State Water Resources Control Board

December 8, 2020

CUYAMA VALLEY GROUNDWATER SUSTAINABILITY PLAN, GROUNDWATER BASIN NO. 3-013

Figure A-1: Nitrate Detections (yellow and green) and MCL Exceedances (red) in Drinking Water Wells.

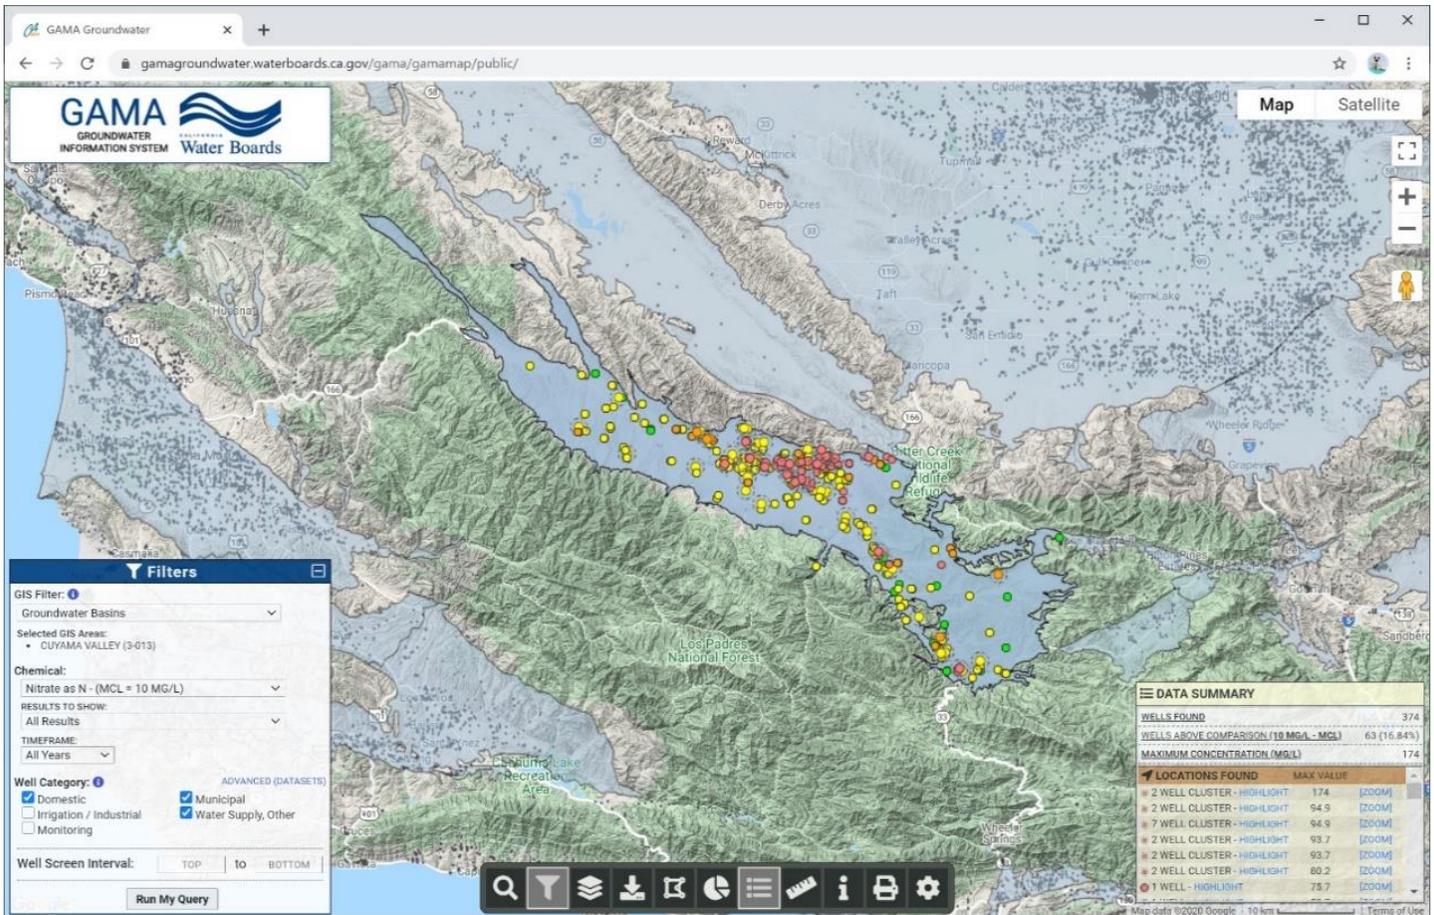
1. The GSP should include nitrate and arsenic sustainable management criteria (SMC). In general, in deciding which water quality constituents to consider when setting SMC, a Groundwater Sustainability Agency (GSA) should consider the best available water quality information for the basin, including data used to develop the hydrogeologic conceptual model, geochemistry of geological formations (for the potential of mobilization of natural constituents), and groundwater uses in the vicinity of the representative monitoring sites and the

- a. Nitrate Maximum Contaminant Level (MCL) exceedances in domestic wells have occurred over wide areas within the basin, while arsenic MCL exceedances have been found near the New Cuyama area and have impacted Cuyama Community Service District's (CCSD's) public supply well. Figures A-1 and A-2 in the Appendix show the locations of detections and MCL exceedances for nitrate and arsenic, respectively.

2. In conclusion, staff recommend that the GSP include SMC and monitoring for nitrate and arsenic, and that the GSA coordinate with the Central Coast Water Board in setting MTs and developing a plan for addressing water quality degradation caused by continued pumping or other actions under the GSA's authority. The GSP's definition of an undesirable result for water quality degradation is not clearly linked to consideration of beneficial users of water and is not specific to each of the threshold regions for managing water levels. The GSP defines the undesirable result as "when 30 percent of the representative monitoring points (i.e., 20 of 64 sites) exceed the MT for a constituent for two consecutive years" (Section 3.6.4, p. 3-4). The six threshold regions each have unique characteristics in hydrogeology, land use and water use practices, and existing conditions of water level and water quality. For example, agricultural practices and groundwater pumping are extensive in the Eastern and Central threshold regions, moderate in the Western threshold region, and beginning to develop in recent years in the Northeastern threshold region. The areas with agriculture are more prone to water quality issues (e.g., see Figures A-1 and A-2 for nitrate and arsenic). Defining the undesirable result as 30 percent of wells exceeding the MT across the six threshold regions could dilute signals of local impacts and, when evaluated, cause water quality degradation in areas of concern to appear less notable. Staff recommend the GSA develop specific water quality SMC for each threshold region and more clearly tie whatever threshold the GSA uses to beneficial users, especially for the threshold regions with agricultural land and groundwater pumping. The GSA should reach out to beneficial users in each threshold region for input in the development of these SMC.

Figure A-2: Arsenic Detections (yellow and green) and MCL Exceedances (red) in Drinking Water Wells.

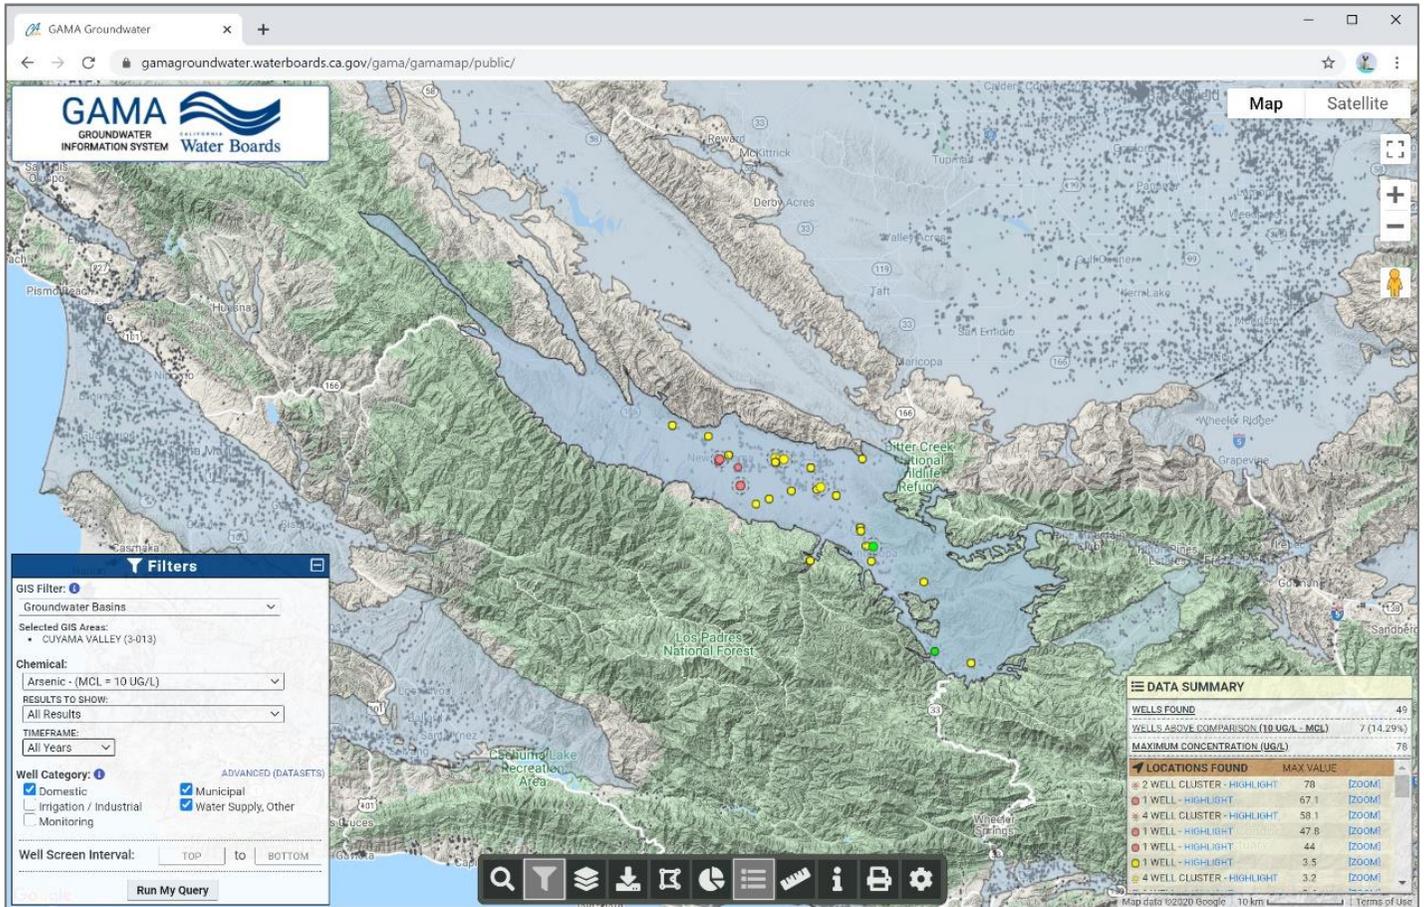
- c. The GSP states that arsenic near New Cuyama has only been detected at one of the CCSD's inactive wells or at depths greater than 700 feet and outside of range of drinking water pumping, and that uncertainty about the actual depth of arsenic contamination makes setting SMC infeasible (GSP Section 2.2.10, p. 2-121); however, staff from the State Water Board's Division of Drinking Water note that arsenic necessitates expensive treatment at the CCSD's sole public drinking water supply well, which is approximately 800 feet deep. In addition, the State Water Board's Groundwater Ambient Monitoring and Assessment Program's Groundwater Information System shows records of arsenic MCL

exceedances in drinking water wells perforated in both shallower (e.g., top of perforation at a depth of 340 feet) and deeper groundwater.

- d. The GSP reasons that the GSA cannot set SMC for arsenic because concentrations are localized and vary from well to well; however, SGMA does not preclude a GSA from addressing localized water quality issues that may be exacerbated by pumping or management actions. In addition, arsenic detections in drinking water wells range in concentration between 1 microgram per liter and the MCL of 10 micrograms per liter over wide areas of the basin, making the issue relatively widespread (see Figure A-2).
